HIGH POINT PLANNING AREA 64

SITE PLAN 01

**HIGH POINT - PLANNING AREA 64**  
 SITE PLAN 01  
 CITY OF AURORA, COLORADO

DATE:  
 PP01-03/13/2020

SHEET TITLE:  
 SITE PLAN

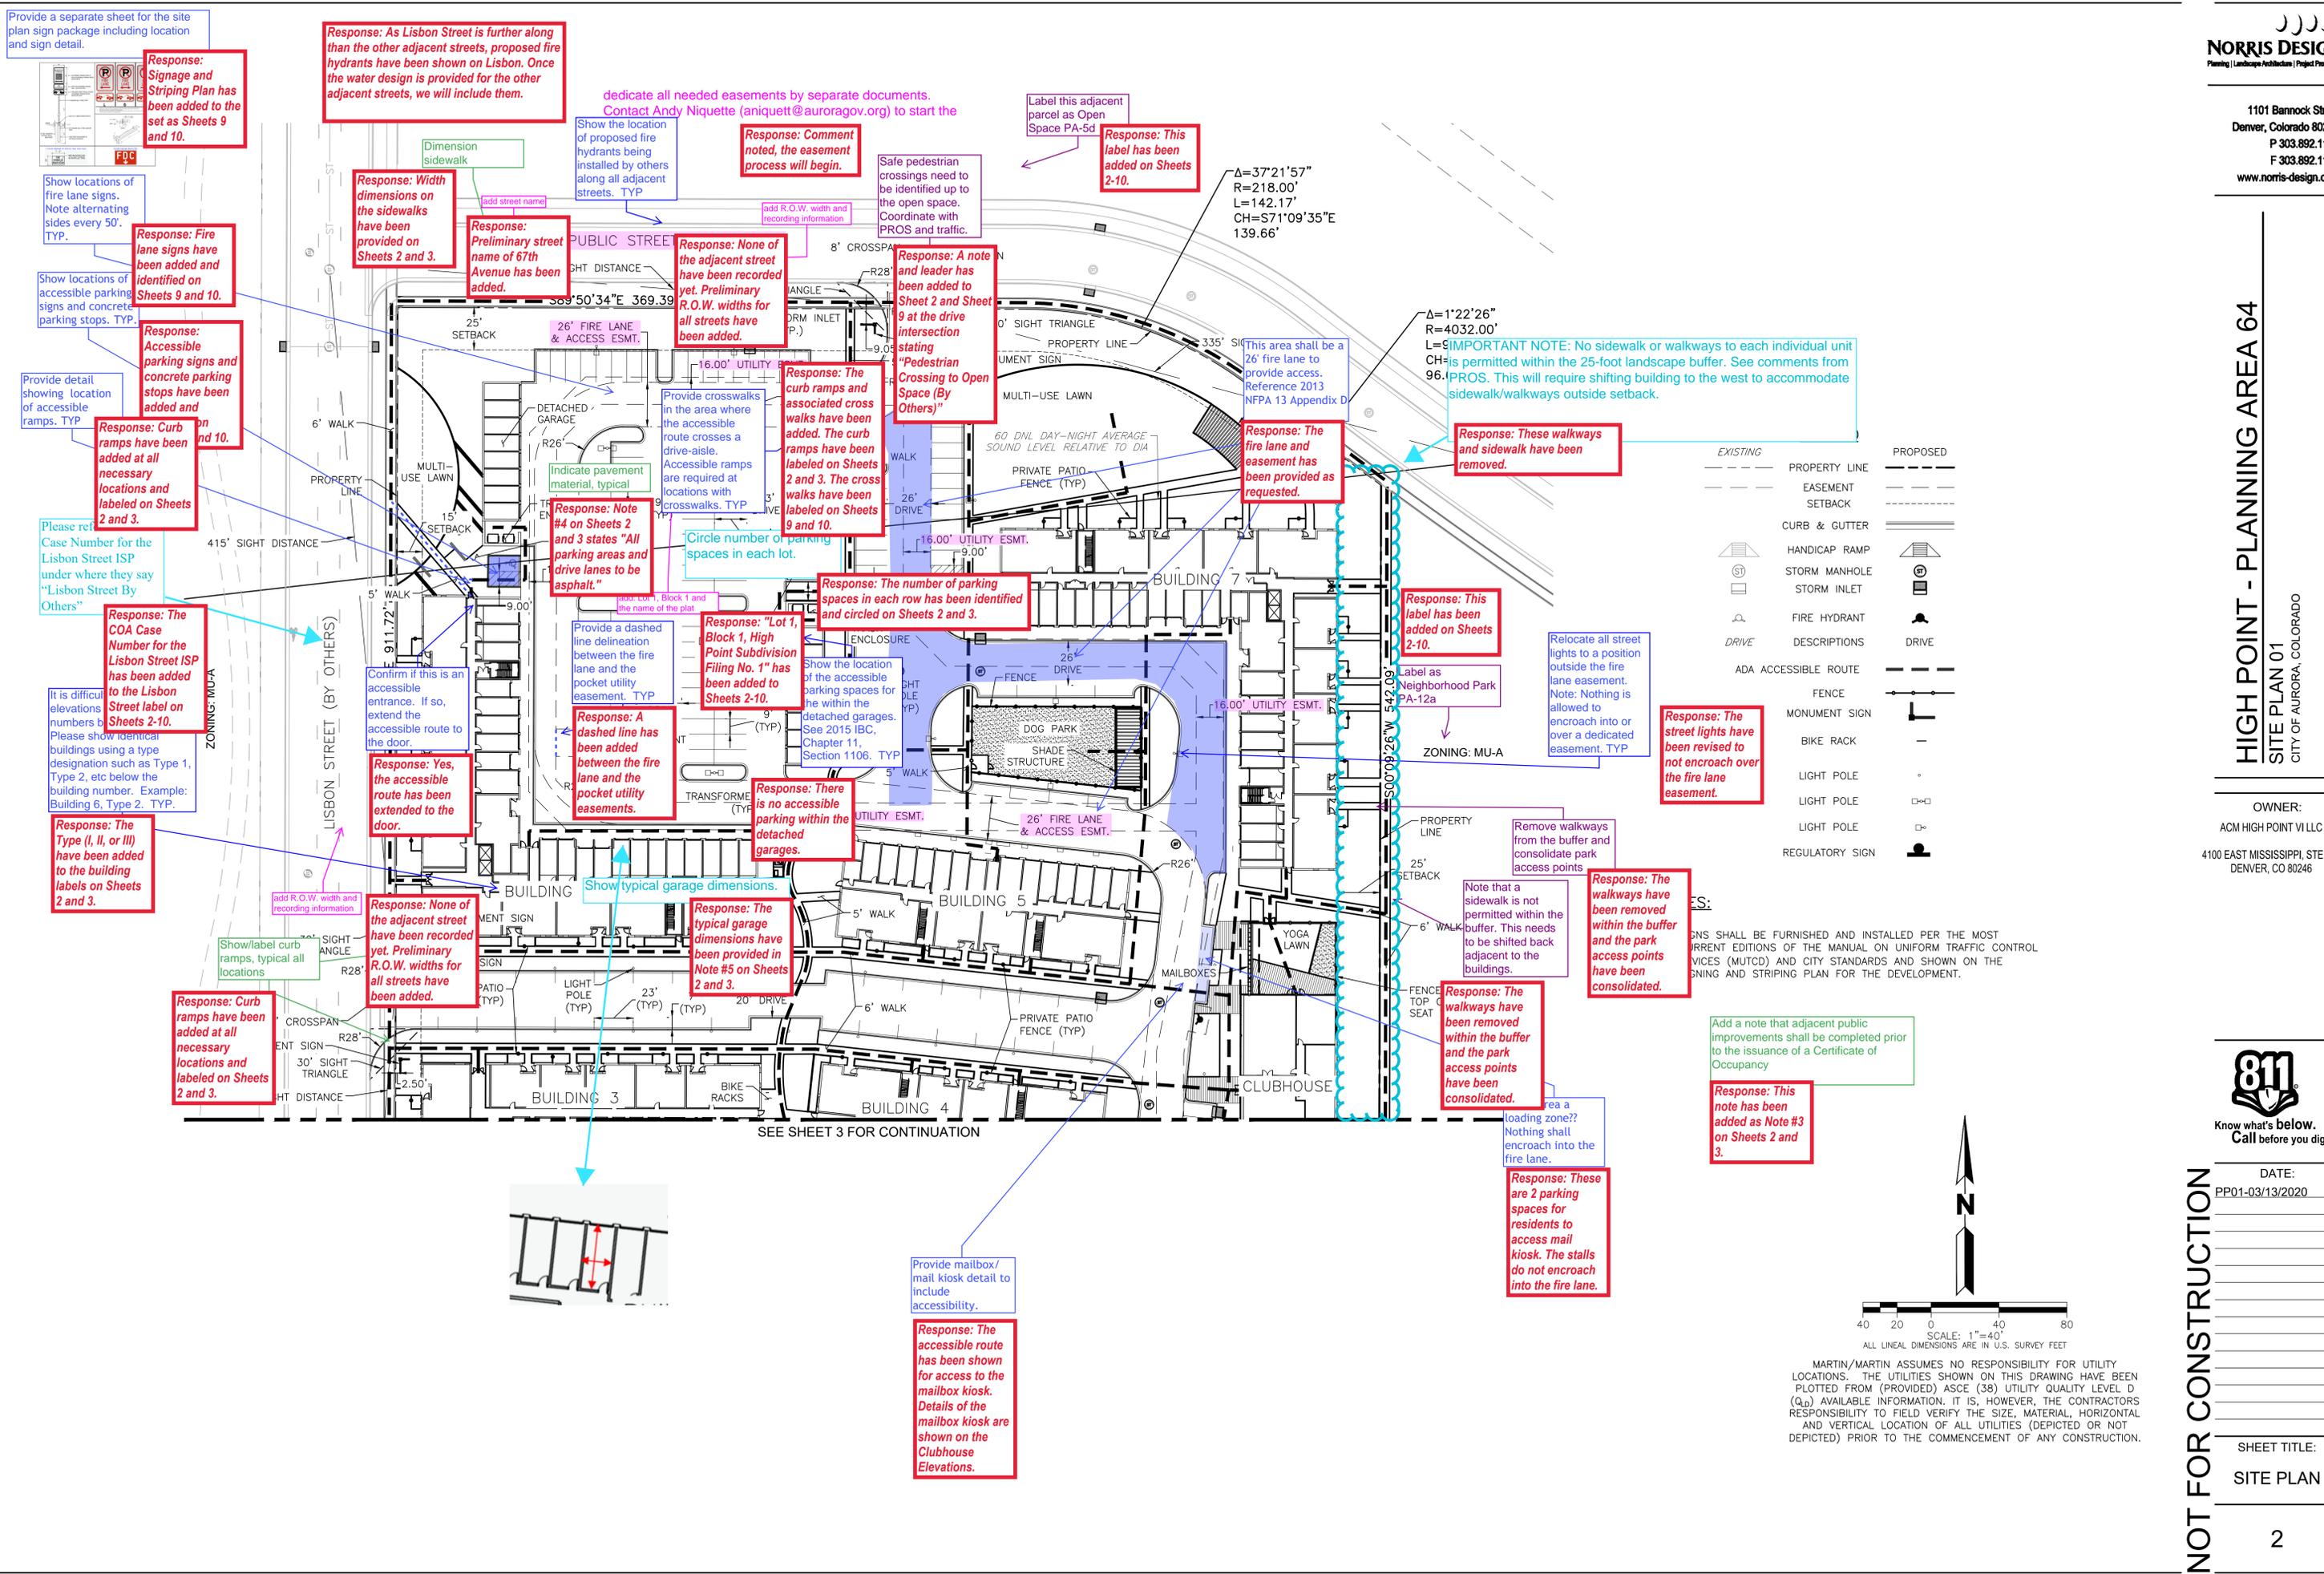
Provide a separate sheet for the site plan sign package including location and sign detail.

Show the location of proposed fire hydrants being installed by others along all adjacent streets. TYP

This area shall be a 26' fire lane to provide access. Reference 2013 NFPA 13 Appendix D

**IMPORTANT NOTE:** No sidewalk or walkways to each individual unit is permitted within the 25-foot landscape buffer. See comments from 96. PROS. This will require shifting building to the west to accommodate sidewalk/walkways outside setback.

Relocate all street lights to a position outside the fire lane easement. Note: Nothing is allowed to encroach into or over a dedicated easement. TYP

Add a note that adjacent public improvements shall be completed prior to the issuance of a Certificate of Occupancy

Provide mailbox/mail kiosk detail to include accessibility.

Please show identical buildings using a type designation such as Type 1, Type 2, etc below the building number. Example: Building 6, Type 2. TYP.

Please refer to Case Number for the Lisbon Street ISP under where they say "Lisbon Street By Others"

Show locations of fire lane signs. Note alternating sides every 50'. TYP.

Show locations of accessible parking signs and concrete parking stops. TYP.

**Response:** Signage and Striping Plan has been added to the set as Sheets 9 and 10.

**Response:** As Lisbon Street is further along than the other adjacent streets, proposed fire hydrants have been shown on Lisbon. Once the water design is provided for the other adjacent streets, we will include them.

**Response:** These walkways and sidewalk have been removed.

**Response:** The fire lane and easement has been provided as requested.

**Response:** The street lights have been revised to not encroach over the fire lane easement.

**Response:** This note has been added as Note #3 on Sheets 2 and 3.

**Response:** The accessible route has been shown for access to the mailbox kiosk. Details of the mailbox kiosk are shown on the Clubhouse Elevations.

**Response:** The Type (I, II, or III) have been added to the building labels on Sheets 2 and 3.

**Response:** The COA Case Number for the Lisbon Street ISP has been added to the Lisbon Street label on Sheets 2-10.

**Response:** Accessible parking signs and concrete parking stops have been added and labeled on Sheets 9 and 10.

**Response:** Fire lane signs have been added and identified on Sheets 9 and 10.

SHEET TITLE:  
 LANDSCAPE PLAN

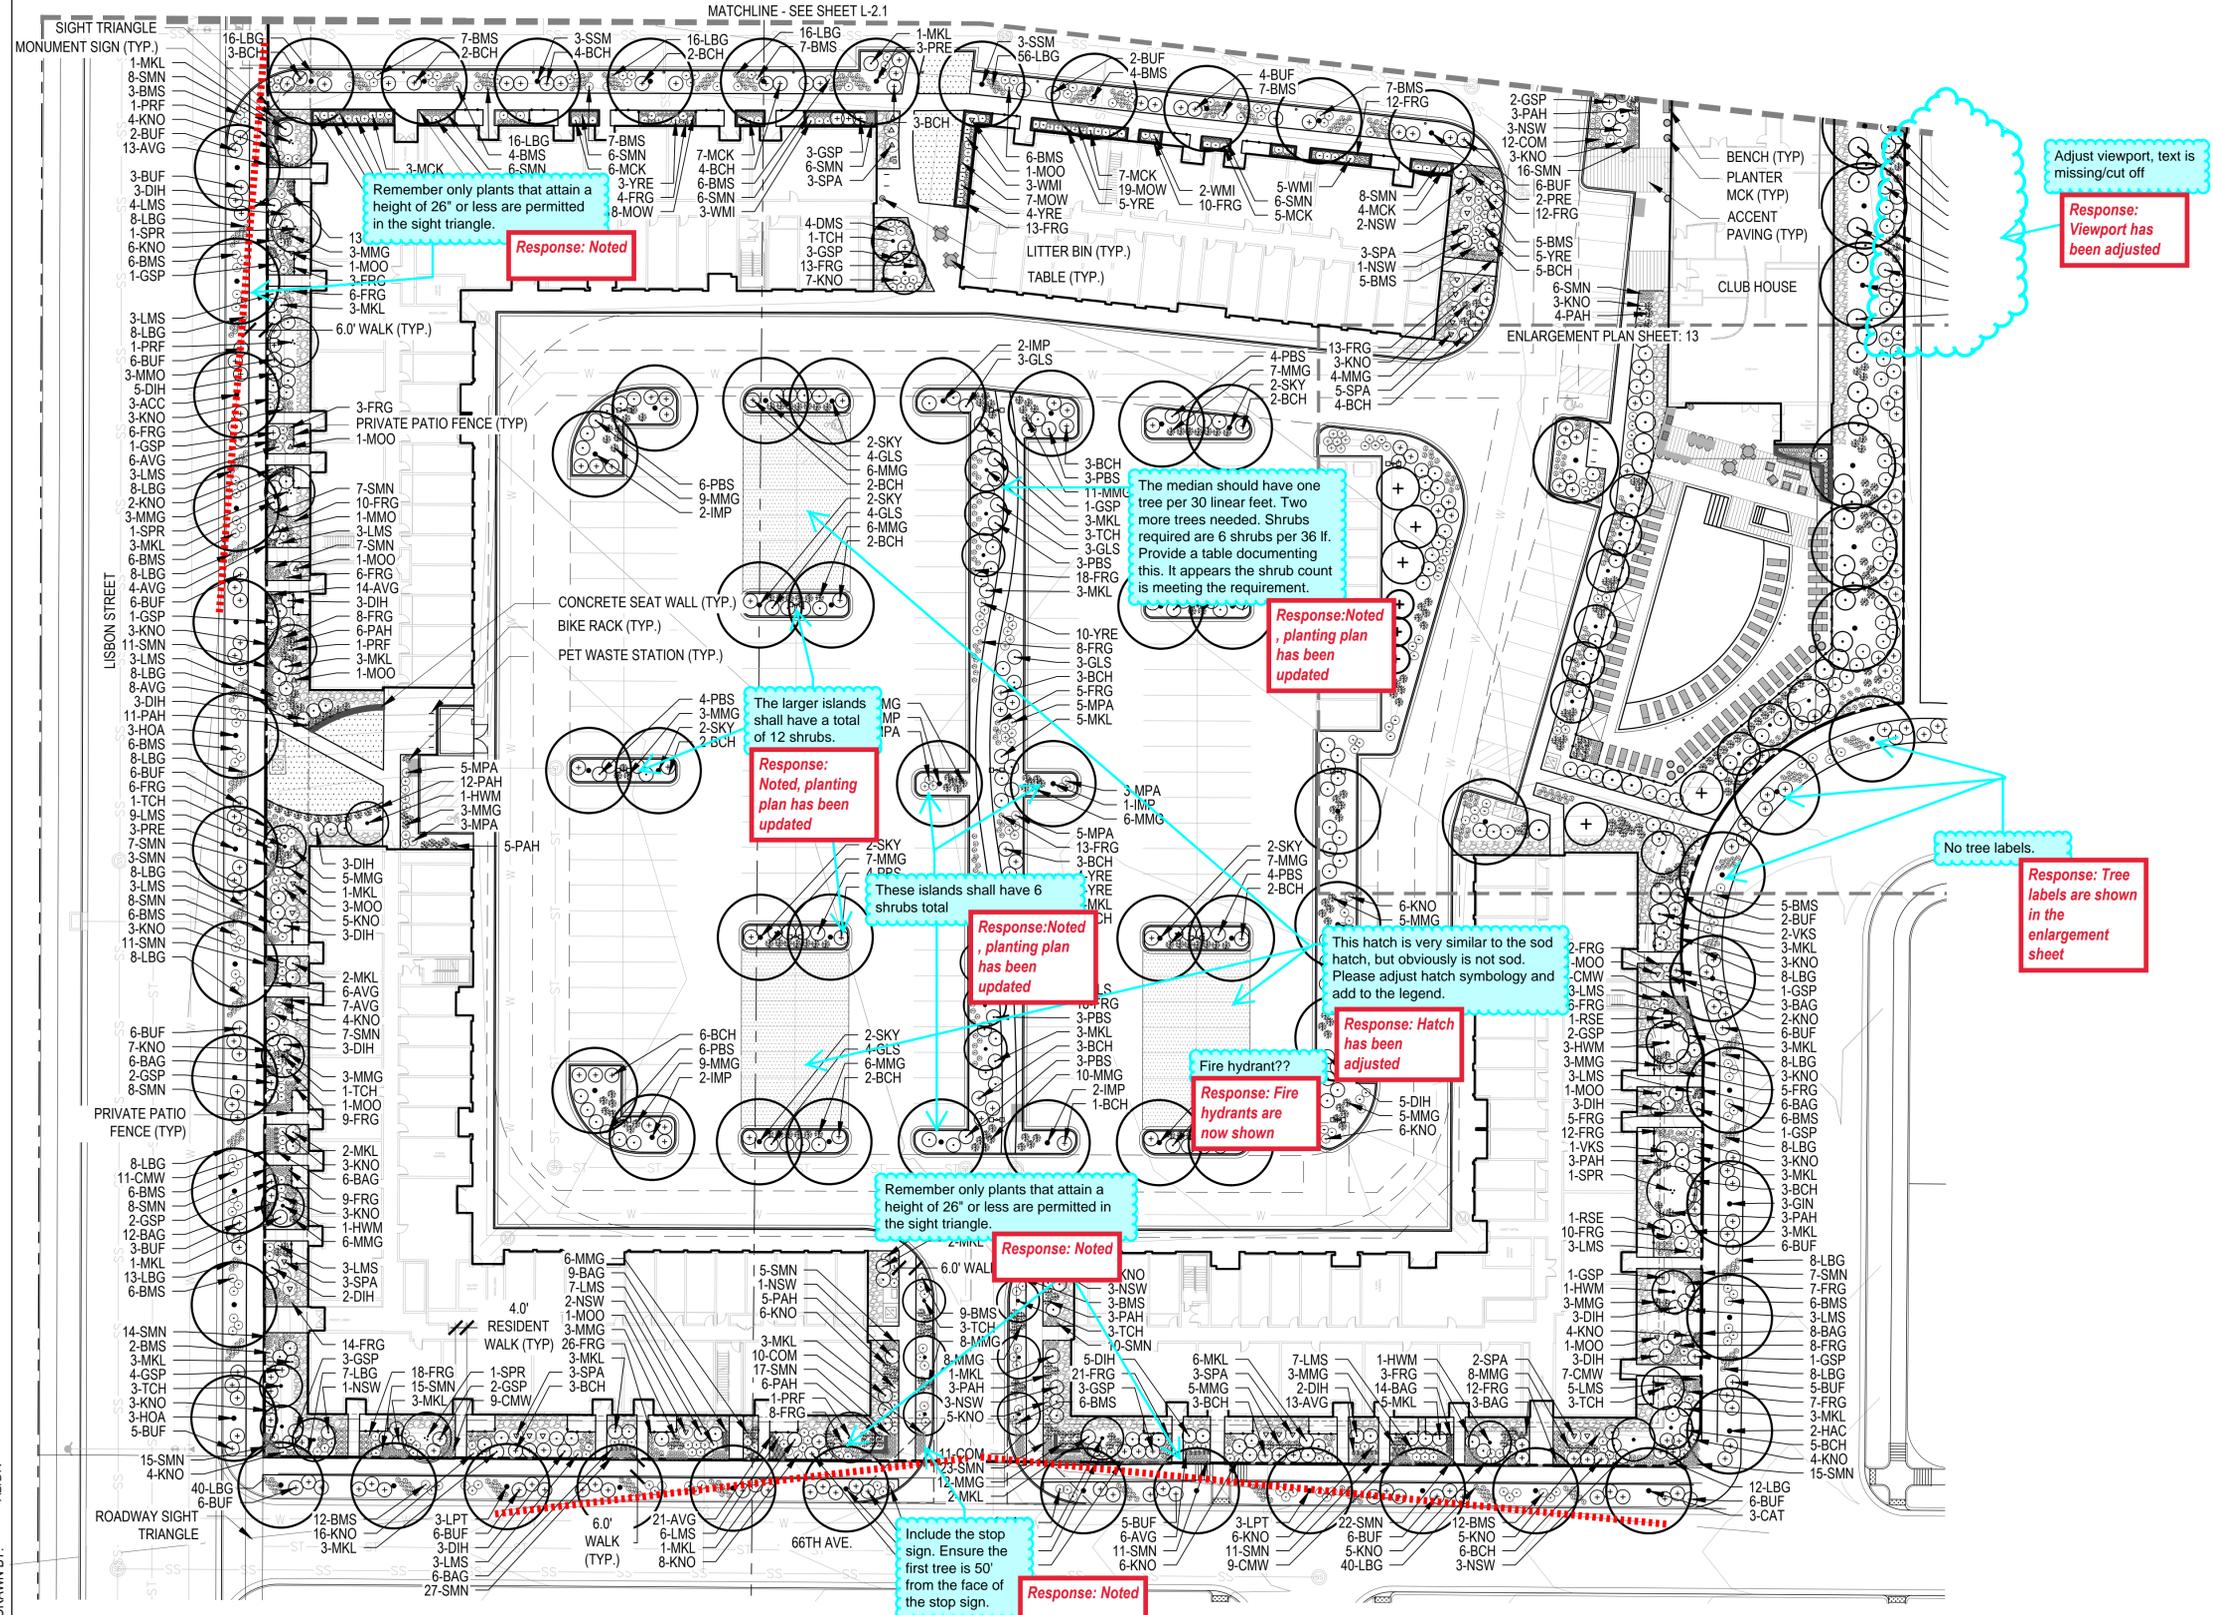
See comments on plan, but no more than 40% of the curbside landscape along each street side can be ornamental grasses. Grasses must be 5 gallon at time of installation. Use more than two shrub species per code. There is to be a variety in height, color and texture. Right now there are just junipers and spirea along all streets.

Response: Noted, planting plan has been updated.

SHEET TITLE:  
 HYDROZONE  
 PLAN

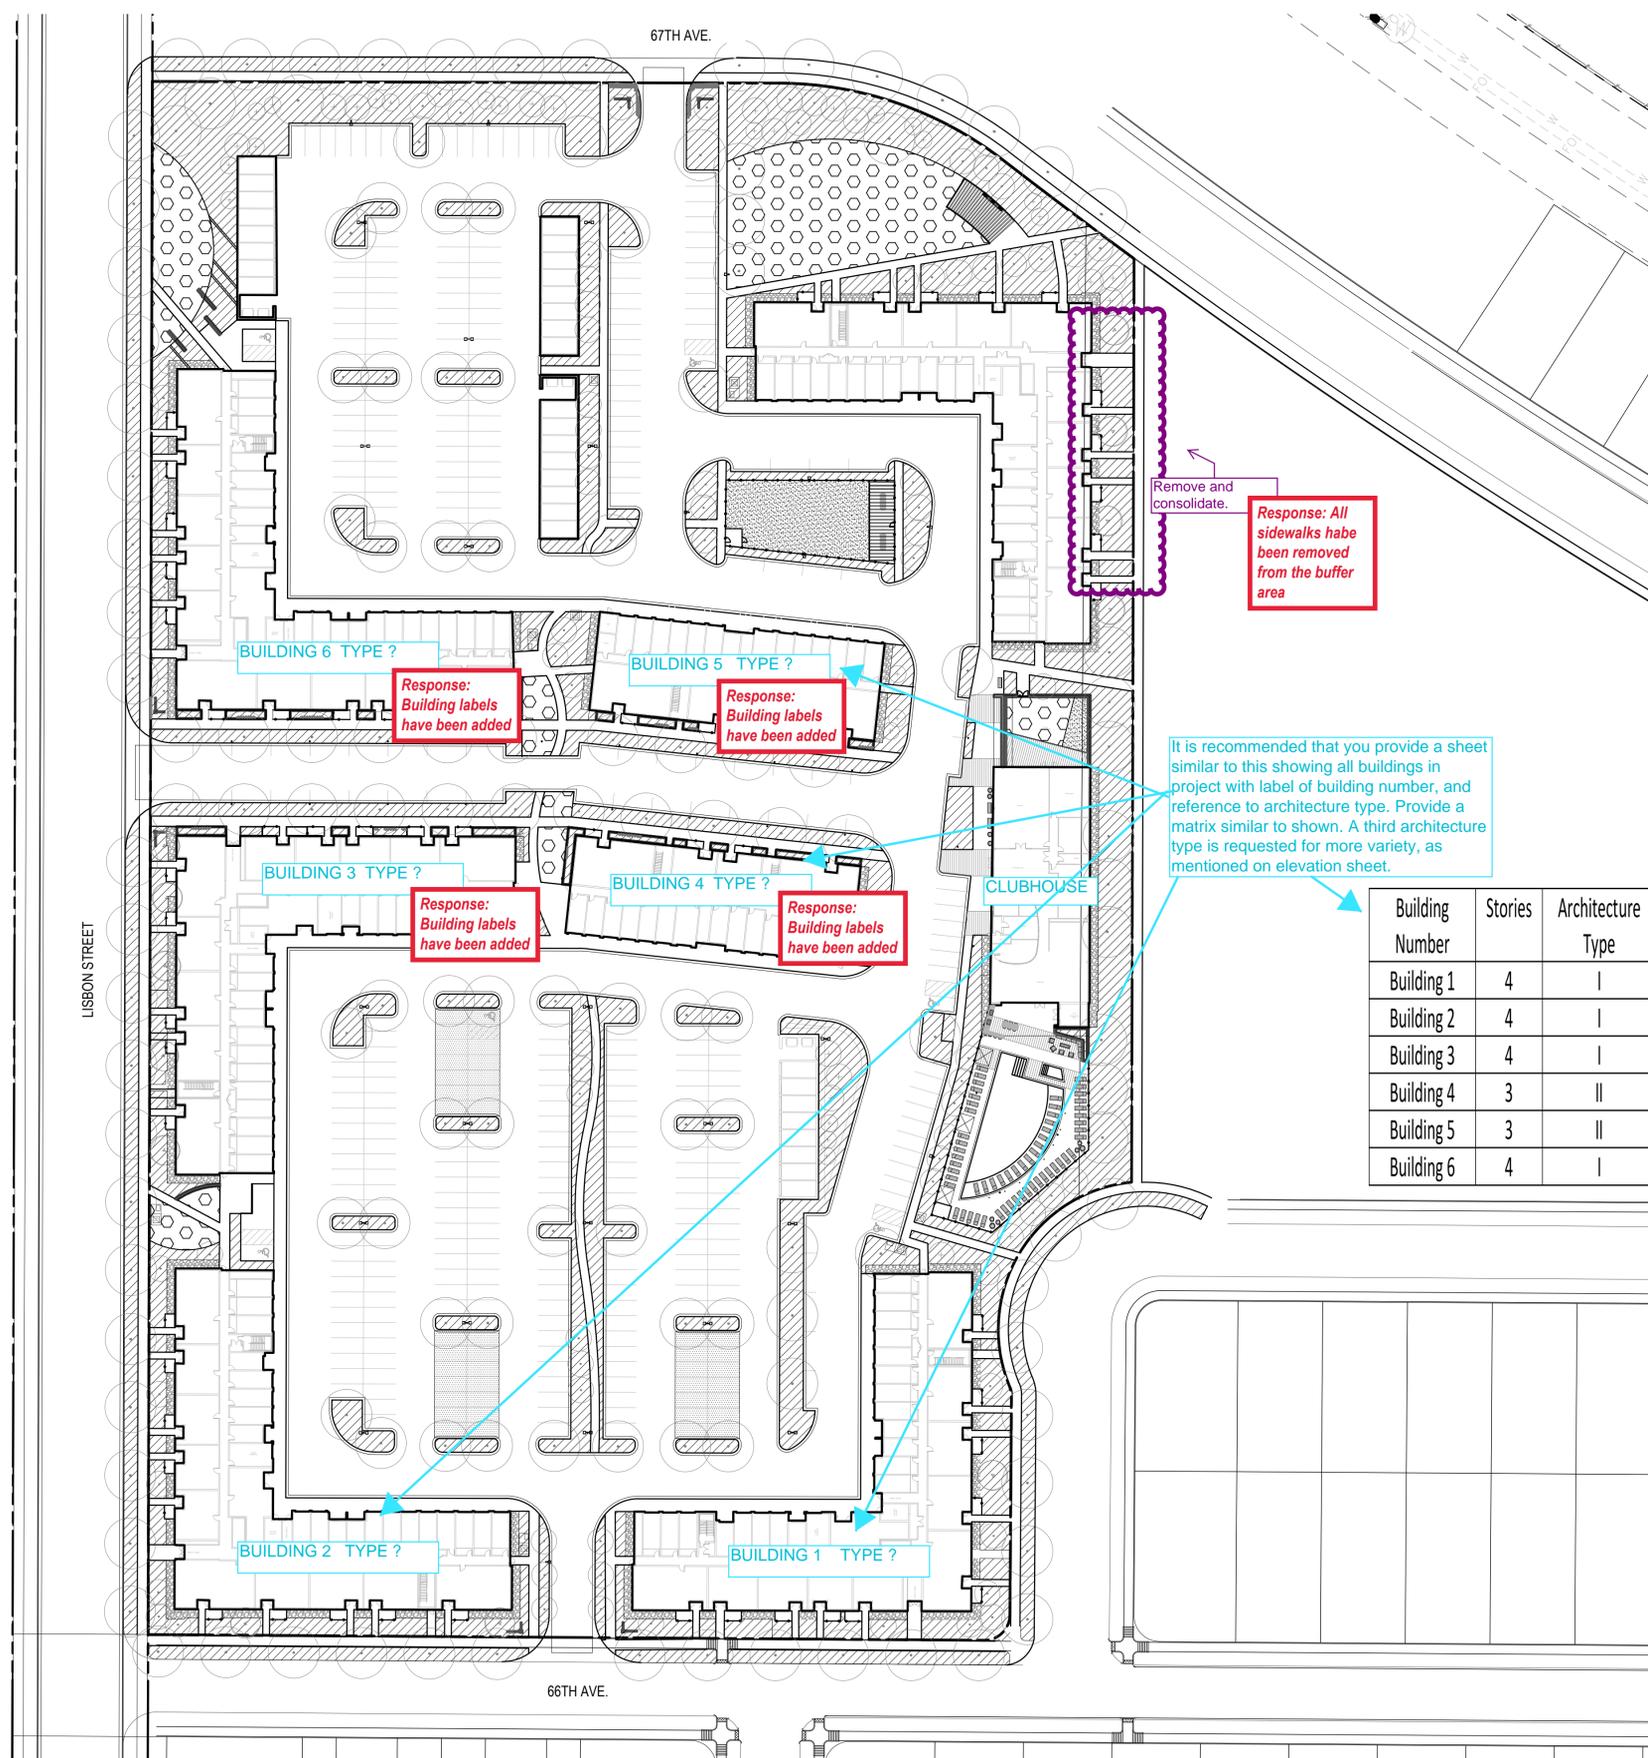
It is recommended that you provide a sheet similar to this showing all buildings in project with label of building number, and reference to architecture type. Provide a matrix similar to shown. A third architecture type is requested for more variety, as mentioned on elevation sheet.

Remove and consolidate.  
**Response: All sidewalks have been removed from the buffer area**

**Response: Building labels have been added**
